River Defence Committee, Alde & Ore Association.

Flood Cell 10 – Chapmans Creek to the Anchorage, Iken by Simon Barrow and Keith Martin Sunday 14th April 2013

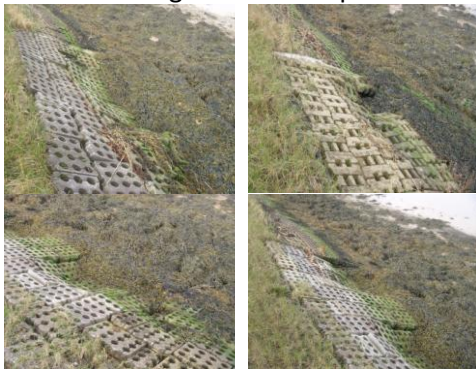
560440 Armour joins out of place
